Access Compliance Report

Public Rights-of-Way

Intersection ID: 12186	Main Street: E_11TH_ST	Cross Street: E_BROOKSHIRE_FR_RA	Location: E
ADA ID: 5816371308A0	Ramp Type: PerpDiag	Initial Pass/Fail: Fail	Overall Compliance: No
			Severity Score: 36.25

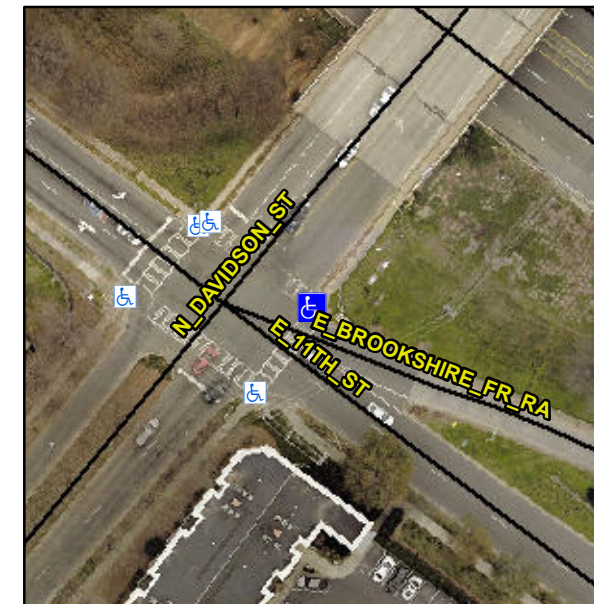
R304.5.1, R304.5.3

Compliance	Description	Data	Compliance	Description	Data
N/A	Ramp Length (in)	67.0	Yes	Ramp Slope (%)	6.6
No	Ramp Width (in)	24.0	No	Ramp XSlope (%)	2.3
N/A	Flare Type LT	N/A	N/A	Flare Type RT	N/A
N/A	Flare Slope LT (%)	N/A	N/A	Flare Slope RT (%)	N/A
N/A	Flare Traversable LT?	N/A	N/A	Flare Traversable RT?	N/A
N/A	Landing Length (in)	N/A	N/A	DWS Provided?	N/A
N/A	Landing Width (in)	N/A	N/A	DWS Contrast?	N/A
N/A	Landing Slope (%)	N/A	N/A	DWS Length (in)	N/A
N/A	Landing X Slope (%)	N/A	N/A	DWS Full Width?	N/A
N/A	Landing Curb? (Y/N)	N/A	N/A	DWS Offset (in)	N/A
N/A	Shared Landing?	N/A			
N/A	Gutter Ponding?	N/A	N/A	Gutter Slope (%)	N/A
N/A	Gutter Lip Ht (in)	3.0	N/A	Gutter X Slope (%)	N/A
N/A	Painted X Walk1?	Yes	N/A	Painted X Walk2?	Yes
	X Walk 1 Direction	To NW		X Walk 2 Direction	To SW
N/A	X Walk 1 Width (in)	104.0	N/A	X Walk 2 Width (in)	104.0
	X Walk 1 Slope (%)	2.3		X Walk 2 Slope (%)	1.6
	X Walk 1 X Slope (%)	3.3		X Walk 2 X Slope (%)	5.6

Remove & Replace Curb Ramp With Two New Directional Ramps or Equivalent.
